**Re: Palomino Bay Addition – Drainage Study in support of the Preliminary Plat  
Second Review**

We have completed our 3<sup>rd</sup> review and offer the following comments. Please refer to the Denton County Subdivision Rules and Regulations dated July 2009 for drainage criteria; hereafter referred to as Criteria Manual.

EXISTING DRAINAGE MAP

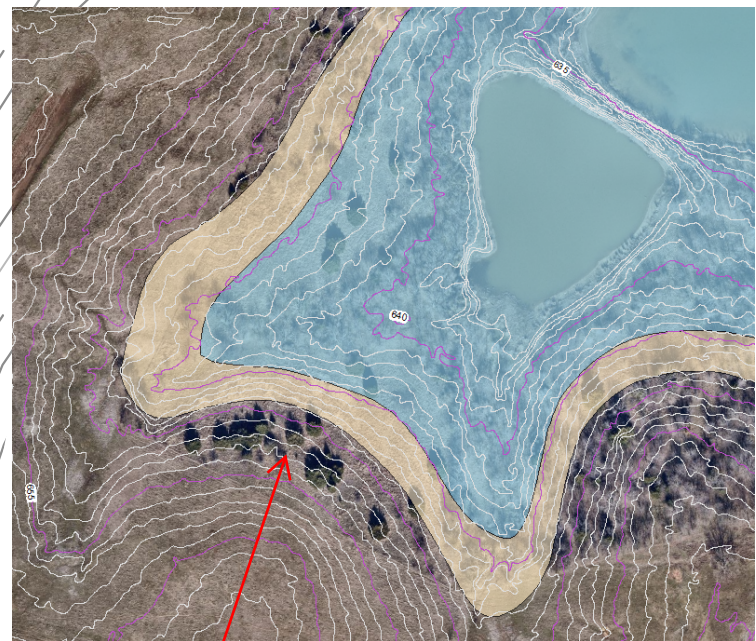
Show and label flowage easement (typically at contour elevation; ie 645.5)

Provide to calculations. Update those larger than 15min

Appears shifted. Based on digital FEMA files, Zone AE is closer to contour shapes.

Show and label flowage easement (typically at contour elevation; ie 645.5)

PROPOSED  
DRAINAGE AREA  
MAP

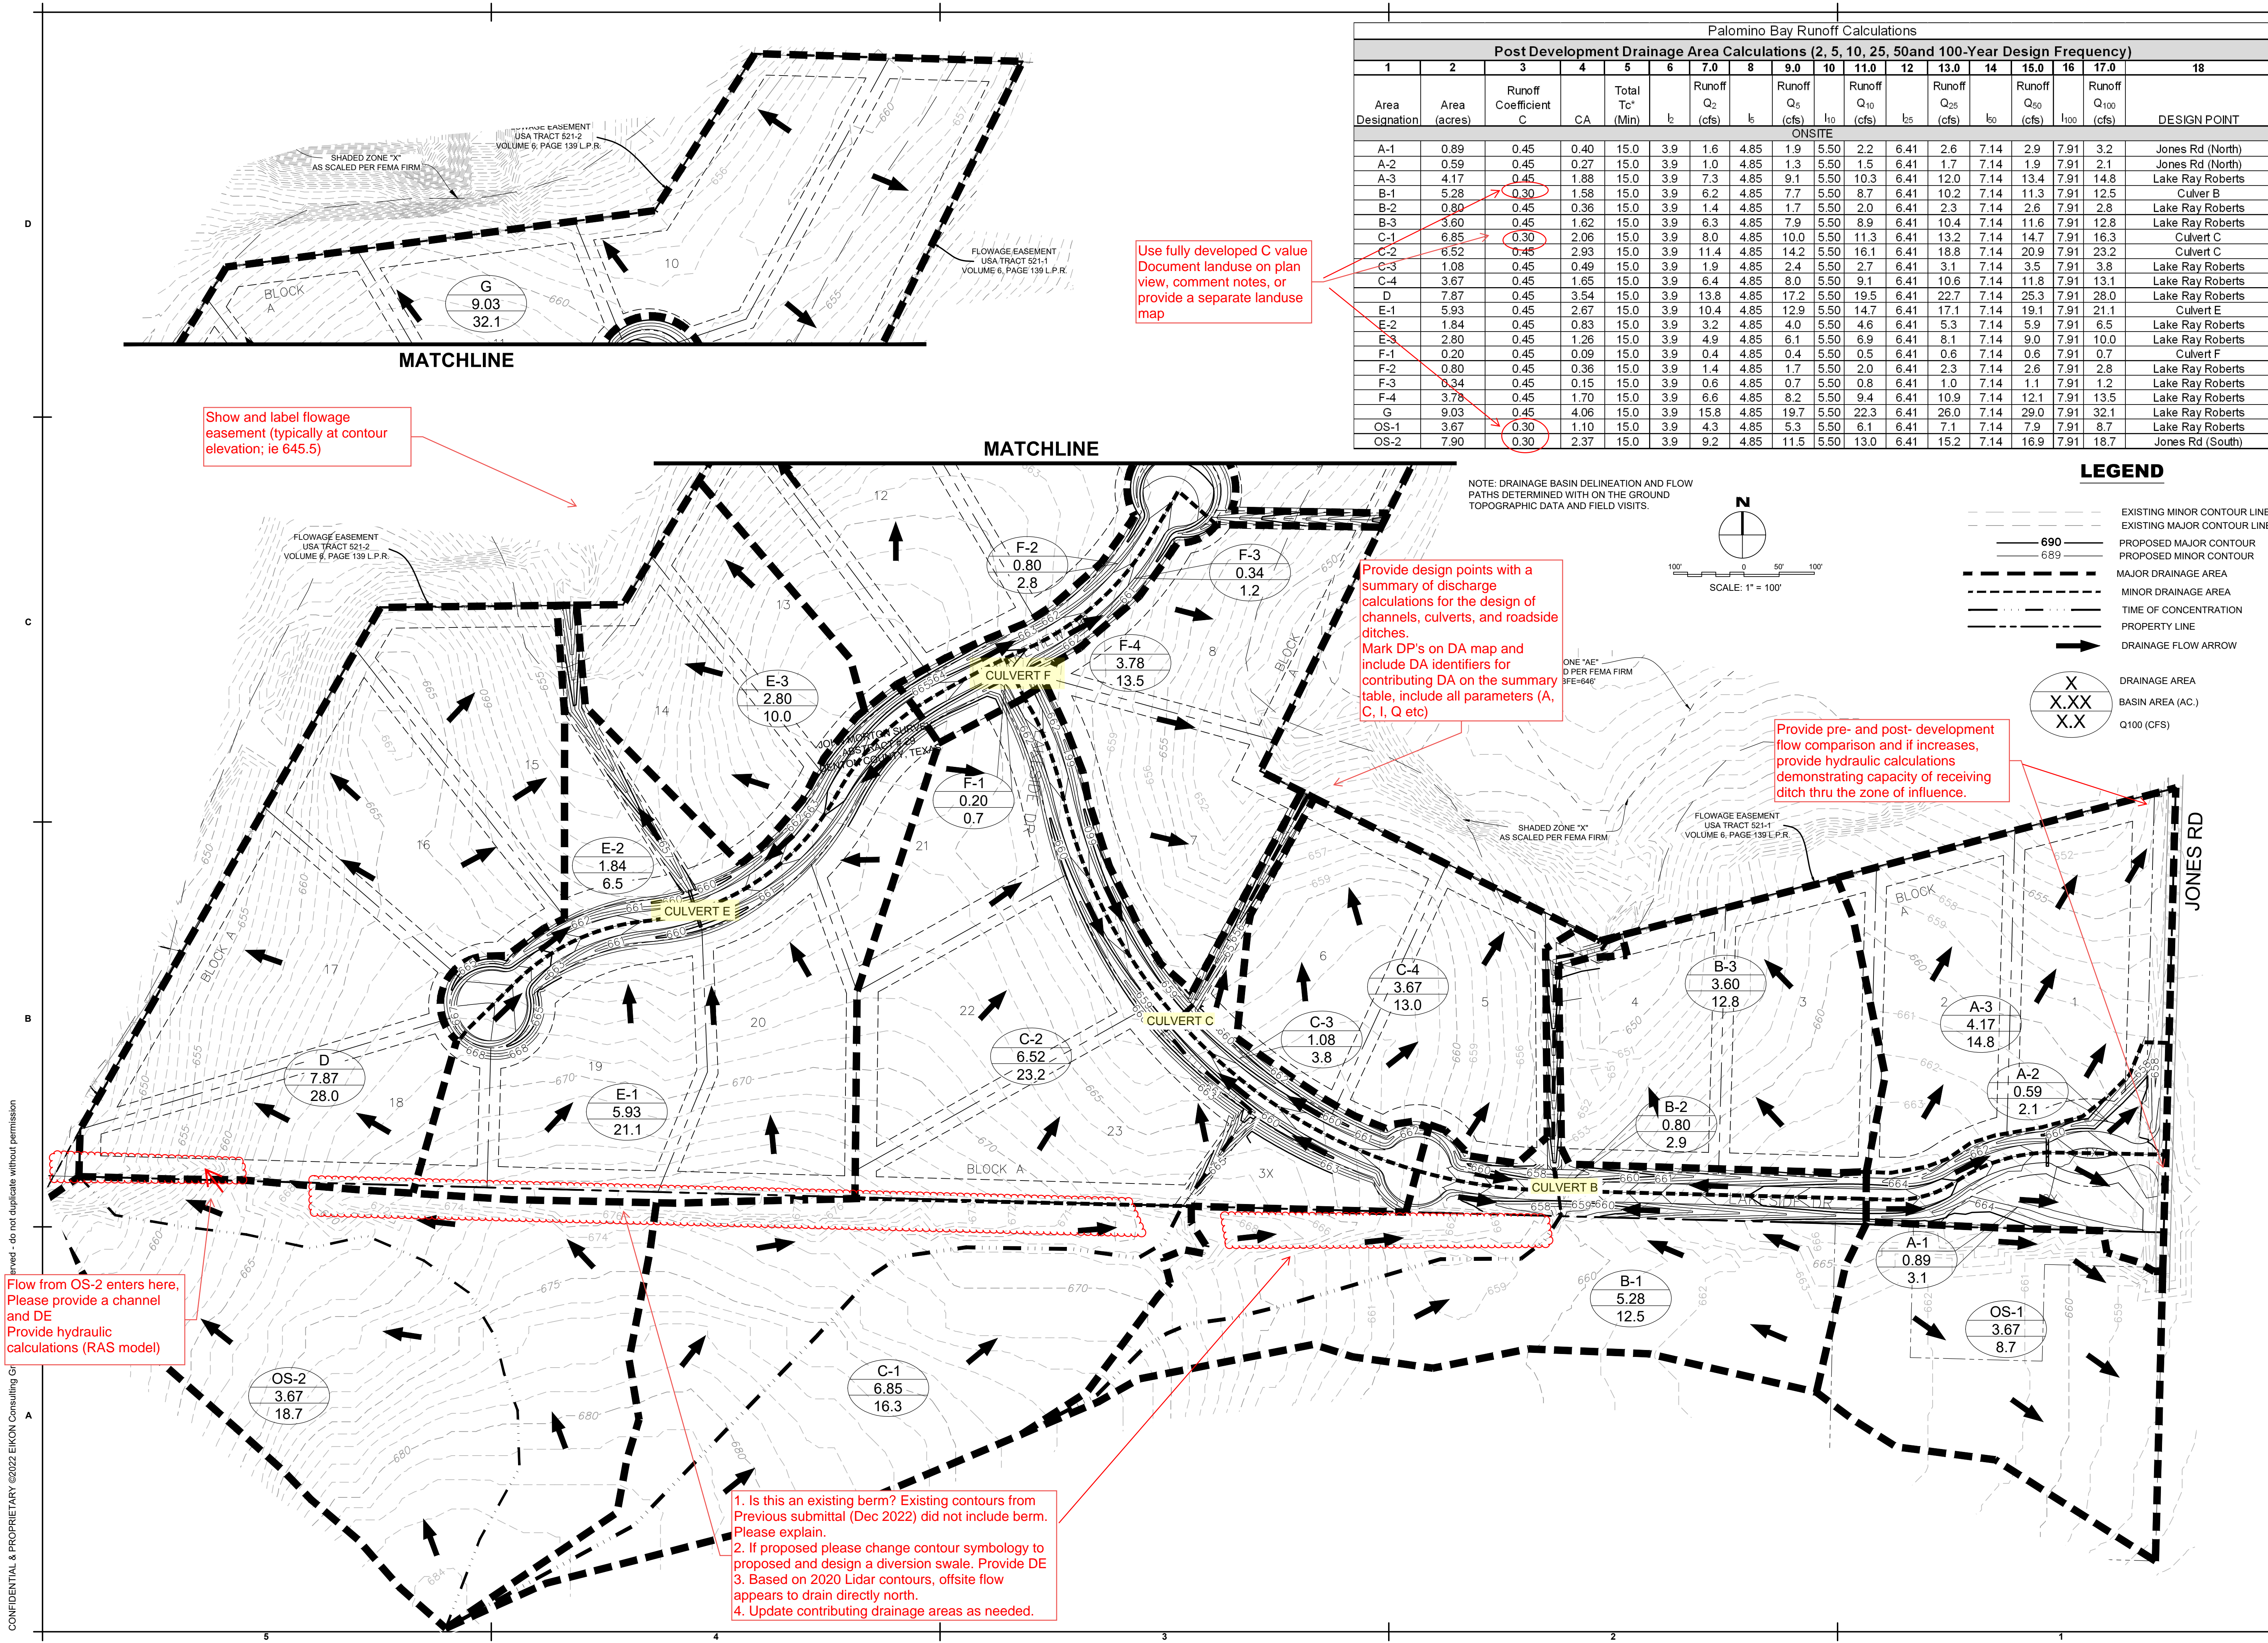
Show and label flowage easement (typically at contour elevation; ie 645.5)

Use fully developed C value Document landuse on plan view, comment notes, or provide a separate landuse map

Provide design points with a summary of discharge calculations for the design of channels, culverts, and roadside ditches. Mark DP's on DA map and include DA identifiers for contributing DA on the summary table, include all parameters (A, C, I, Q etc)

Provide pre- and post- development flow comparison and if increases, provide hydraulic calculations demonstrating capacity of receiving ditch thru the zone of influence.

Flow from OS-2 enters here, Please provide a channel and DE Provide hydraulic calculations (RAS model)

1. Is this an existing berm? Existing contours from Previous submittal (Dec 2022) did not include berm. Please explain.
2. If proposed please change contour symbology to proposed and design a diversion swale. Provide DE
3. Based on 2020 Lidar contours, offsite flow appears to drain directly north.
4. Update contributing drainage areas as needed.

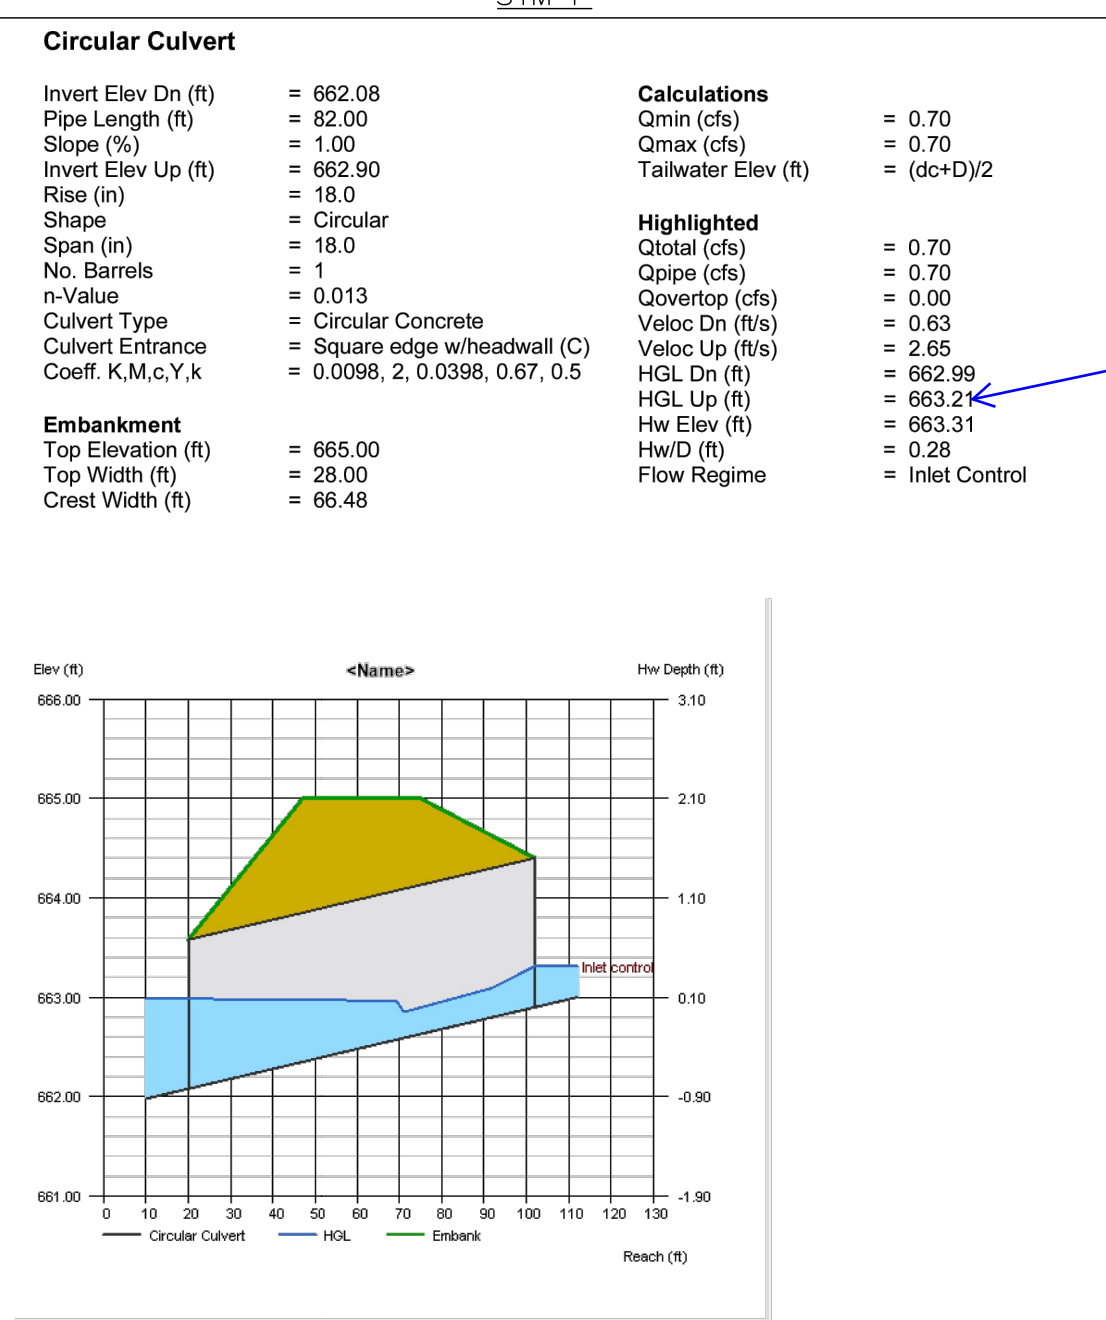
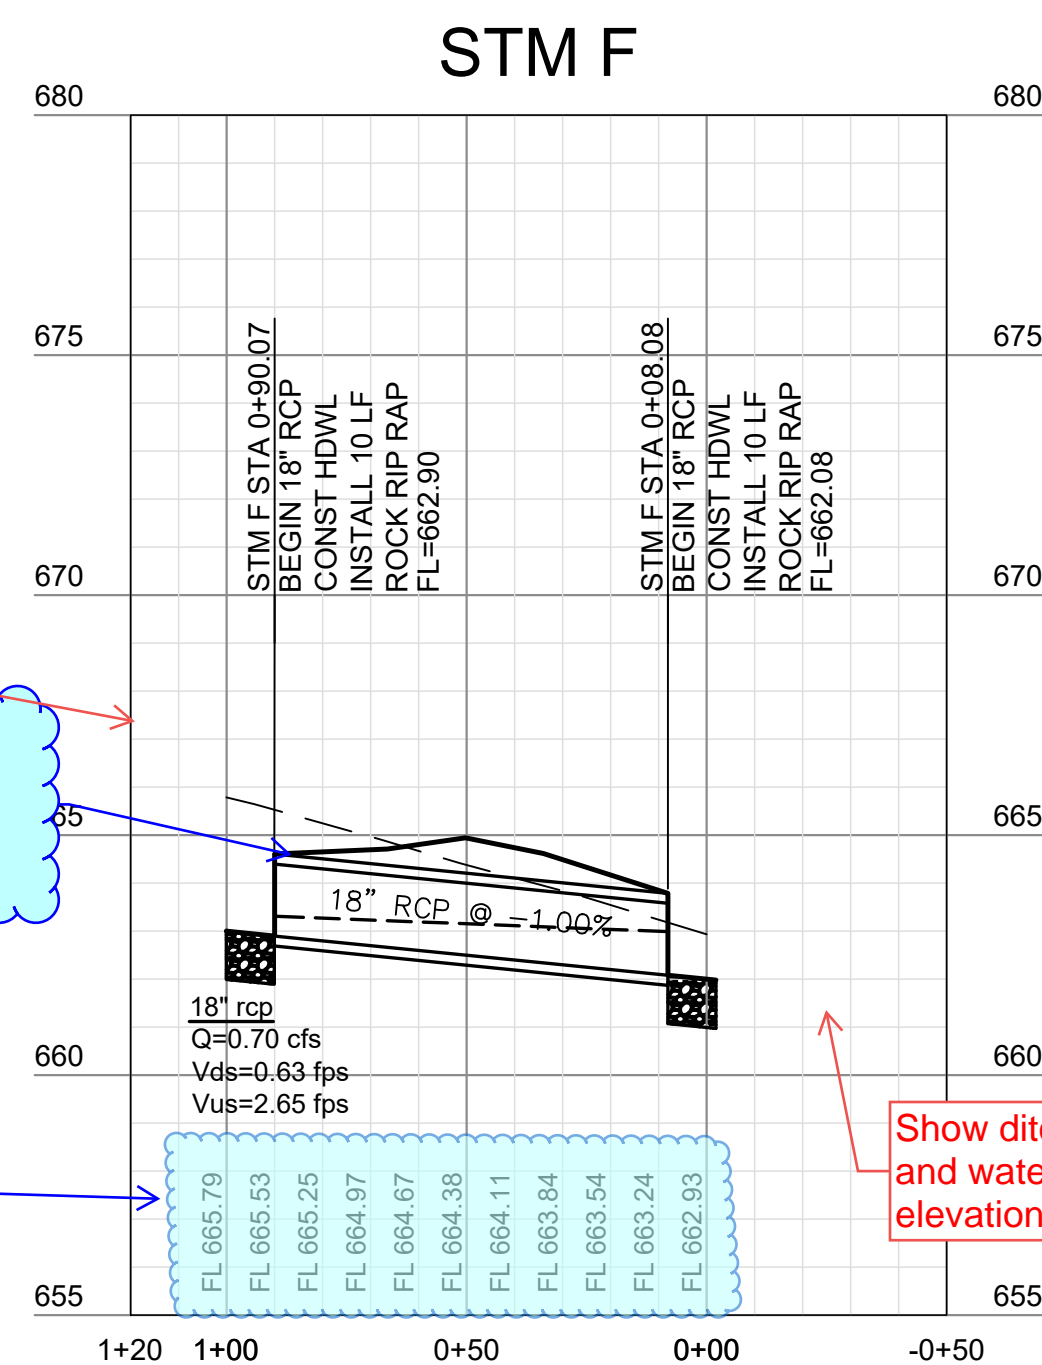
HGL is lower than the upstream invert.

GRADING PLAN II

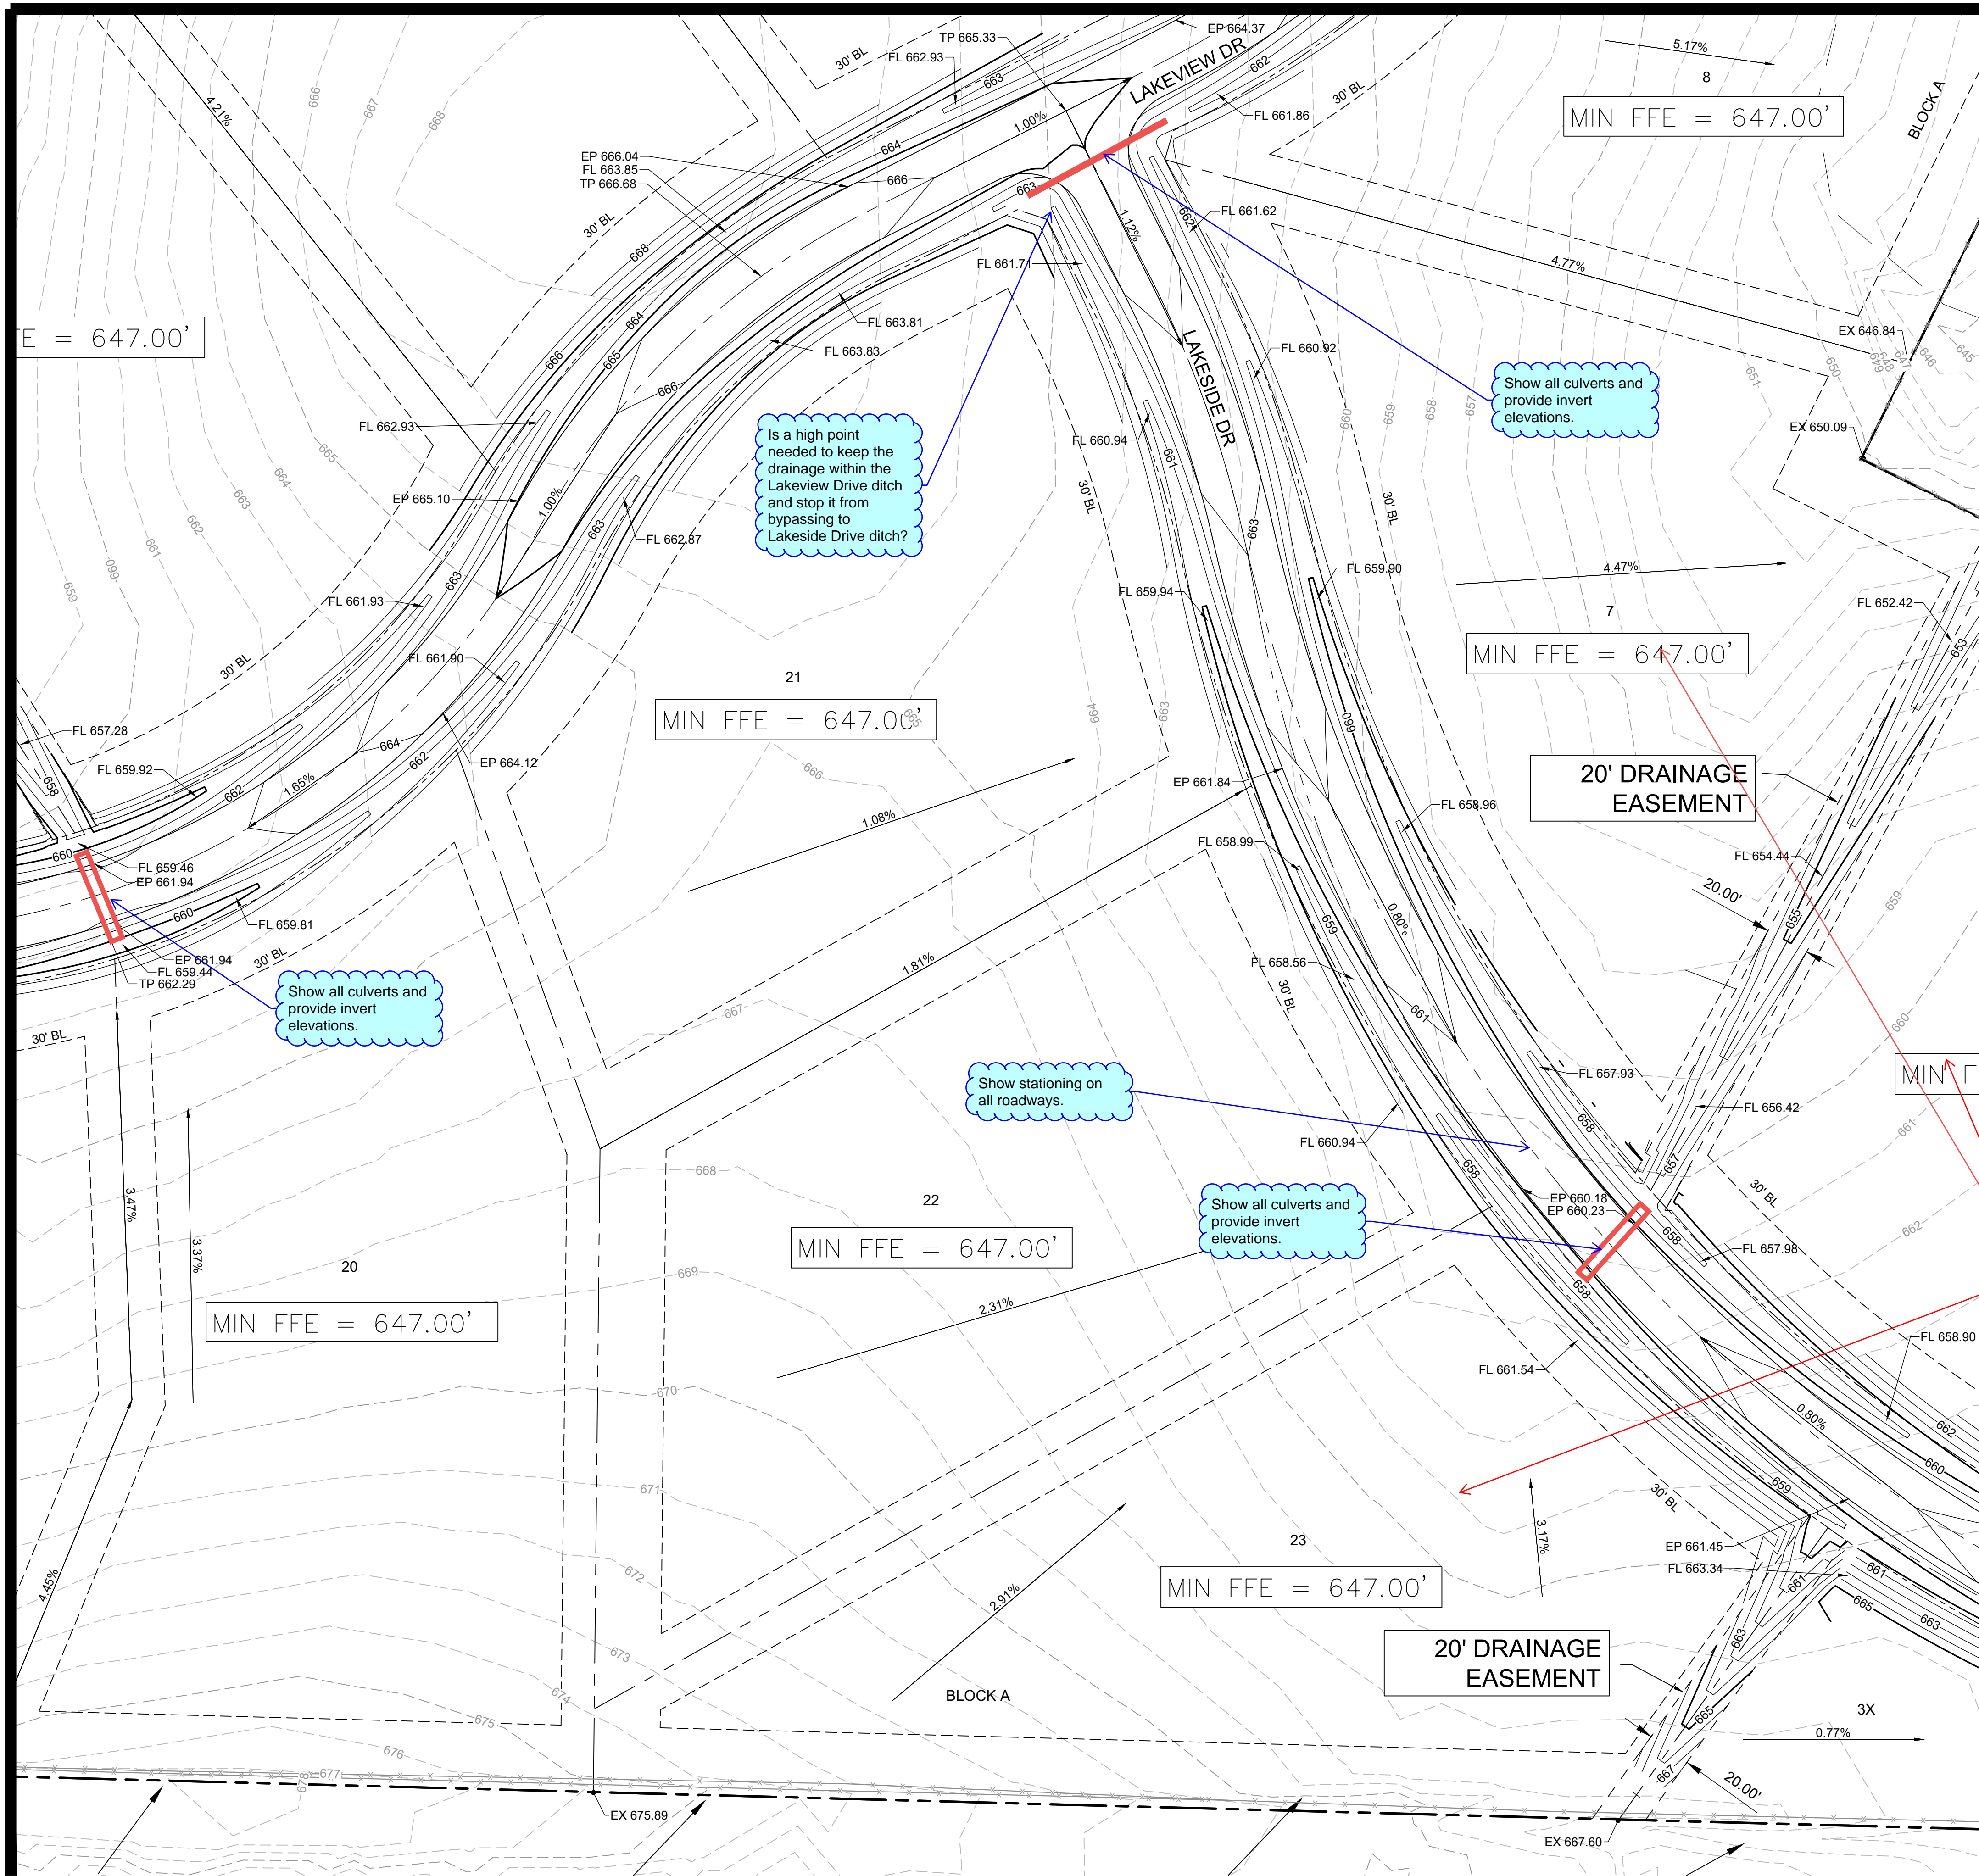
Min FFE must be at least 2' above channels fully developed 100-yr water surface elevation. Use wsel from upstream cross section

Contours do not reflect an 8' flat bottom ditch

Complete all grading.  
Make sure proposed  
contours tie into  
existing contours.

Label existing contours and show tie-ins.  
Show and label riprap

Channel easement needs to include a buffer beyond top of bank for maintenance access (10' )

1. Provide typical cross section for sideyard swales
2. Show proposed flow arrows (typical)

Show and maintain a minimum 30" depth for Barrow ditches Per Denton County subdivision rules and regulations.

Proposed contour elevation 664 tying into existing el 661?

Tie all proposed contours into existing.

Typical section shows an 8' flat bottom ditch but contours do not reflect the 8'.
